SERVICE 		<table border="1"> <tr> <td style="text-align: center; font-size: 2em;">8</td> </tr> <tr> <td style="text-align: center;">X 94.139-26</td> </tr> </table>	8	X 94.139-26
8				
X 94.139-26

Model 36/41

New throttle lock and new throttle lever

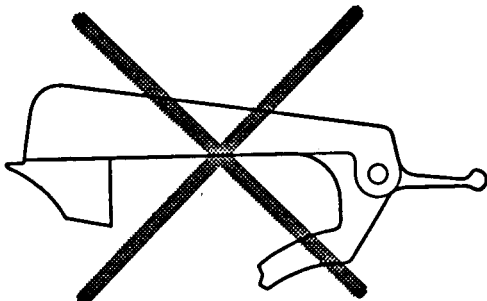
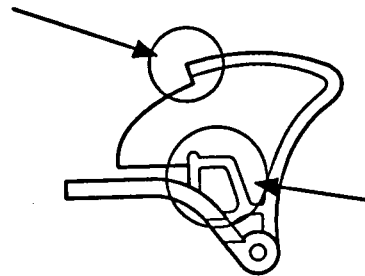
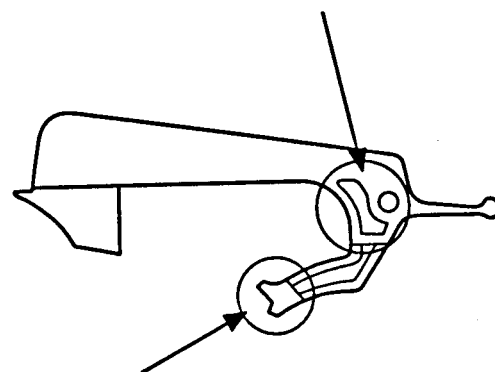
In order to improve the function, both throttle lock and throttle lever are changed in measures.

Introduced from serial number 3140001

NOTE! The new parts are not interchangeable against the old ones. Therefore a kit ref. no. 530 06 95-87 will be introduced which contains the two new parts.
